DEVELOPMENT DETERMINATION PANEL MEETING

WEDNESDAY 24 APRIL 2024

**Agenda for a Meeting of the Development Determination Panel
to be held on Wednesday 24 April 2024
via teleconference
Commencing at 10:00 AM**

ITEM 3.1 REV2024/0001 - 9 LINCOLN AVENUE COLLAROY - REVIEW OF DETERMINATION OF APPLICATION DA2023/0123 FOR ALTERATIONS AND ADDITIONS TO A DWELLING HOUSE INCLUDING A SWIMMING POOL

ORIGINAL DA PLANS

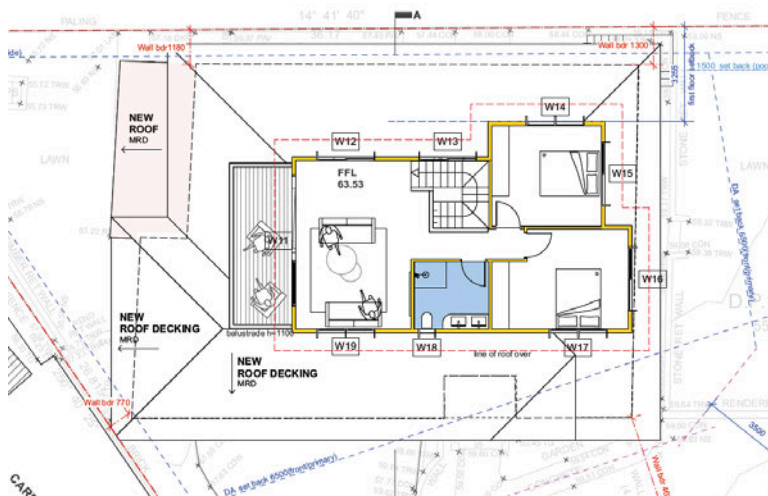
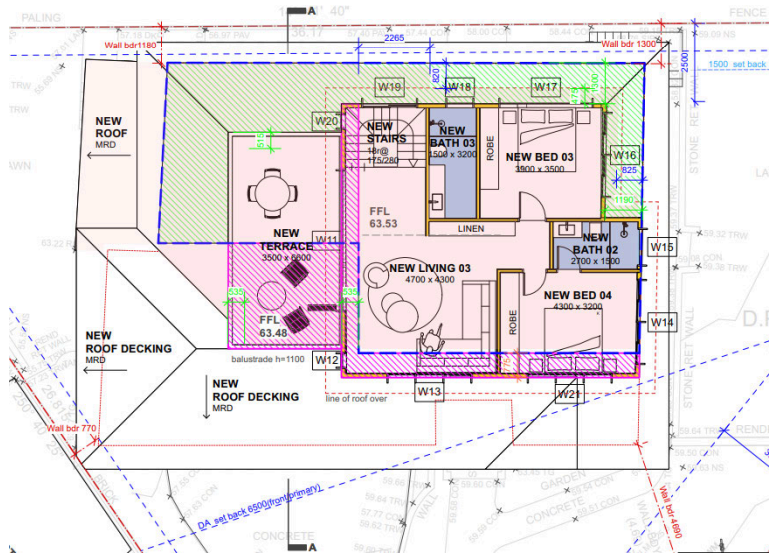
During assessment of the review of determination, Council raised concerns that the proposed development presented a bulk and scale that would unreasonably impact upon the amenity and views of adjacent and nearby properties.

To address these concerns, the applicant submitted plans which included the following amendments to the first floor addition (see image below):

For the benefit of the DDP, below is an extract of the first floor addition plan that was refused, which can be used to compare the siting of the first floor addition under consideration in this review of determination.

Development standard: Clause 4.3 Height of Buildings

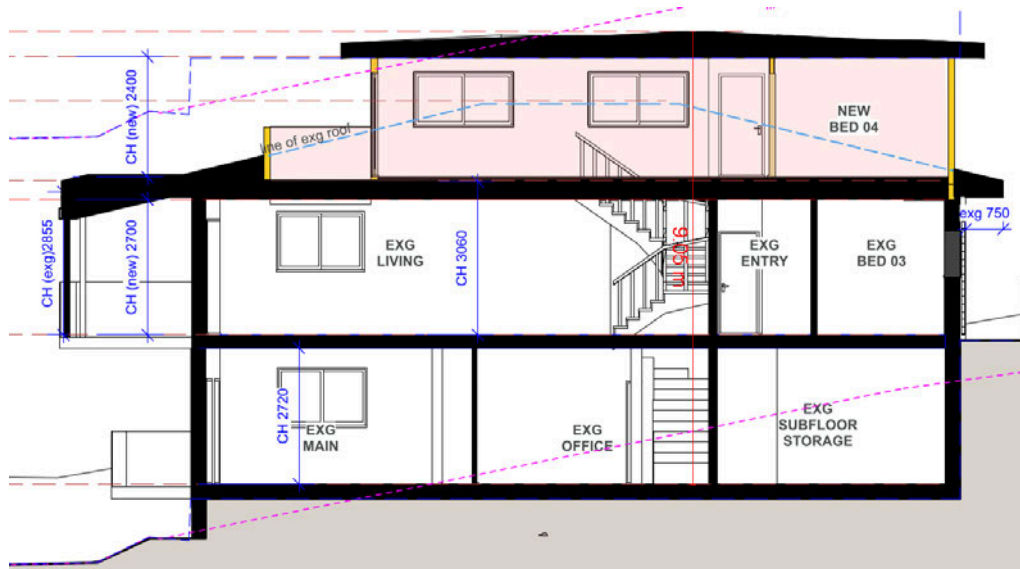
Requirement: 8.5m
Proposed: 9.05m
Percentage of variation: 6.5%

This control requires that walls do not to exceed 7.2 metres from ground level (existing) to the underside of the ceiling on the uppermost floor of the building.

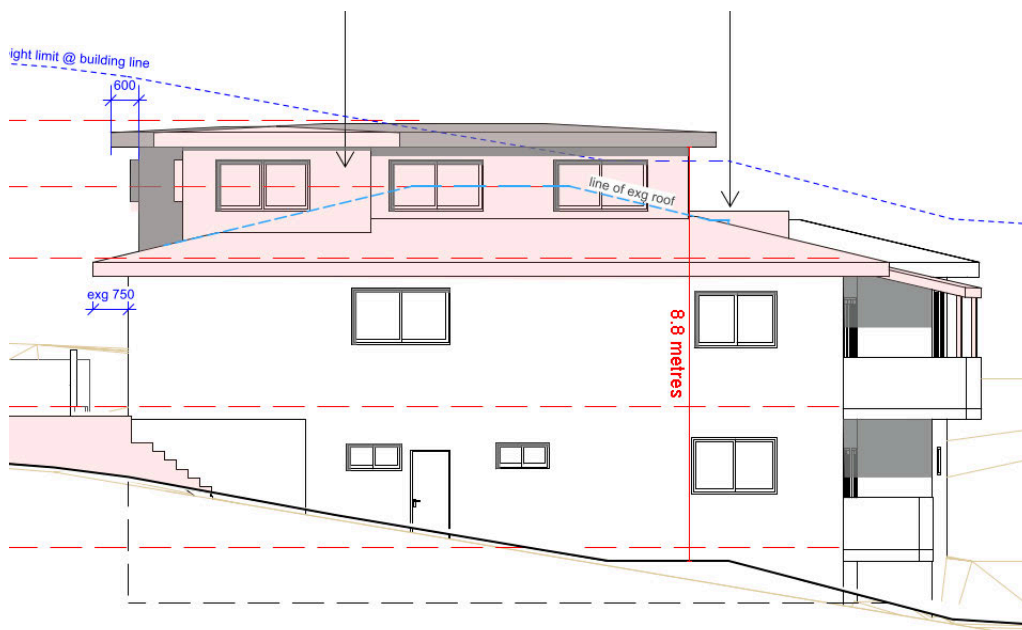
The proposed maximum wall height of the dwelling is 8.8m, representing a variation of 22.2%.

Detailed Assessment**4.6 Exceptions to development standards**

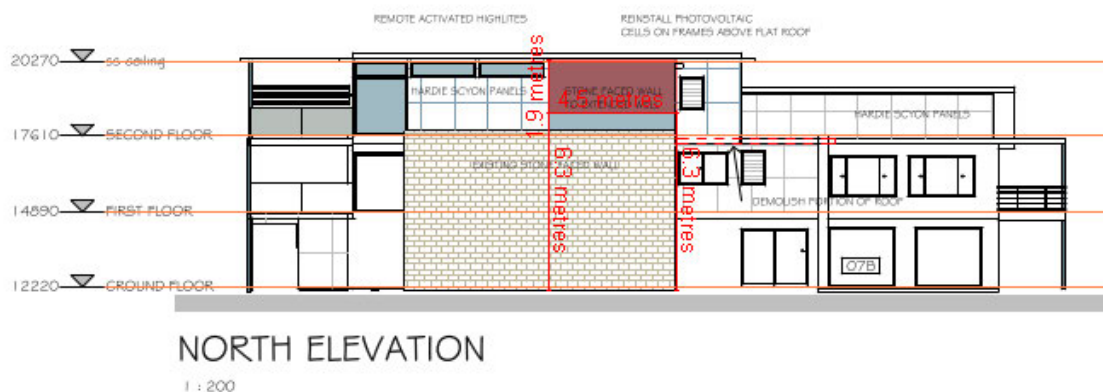
The application seeks consent to vary a development standard as follows:

(Figure 1: Western Elevation - red shading indicates encroachment).

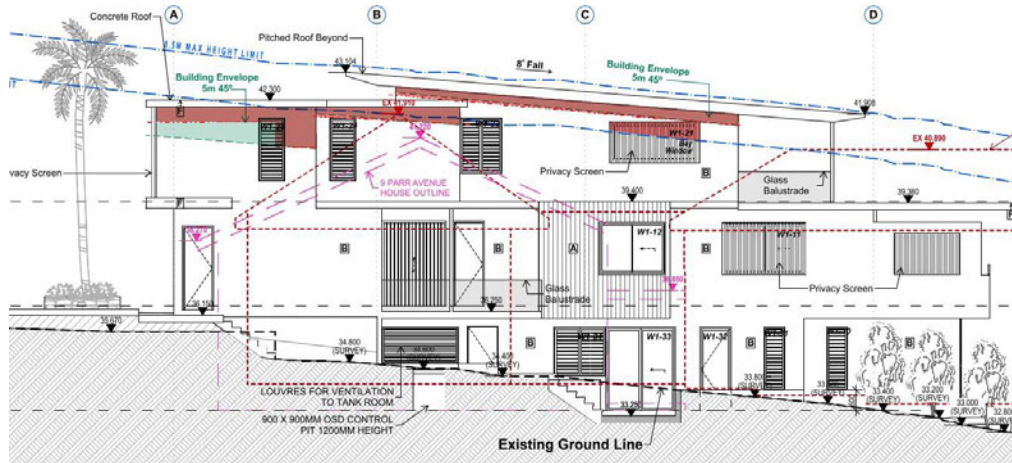
With regard to the consideration for a variation, the development is considered against the underlying Objectives of the Control as follows:
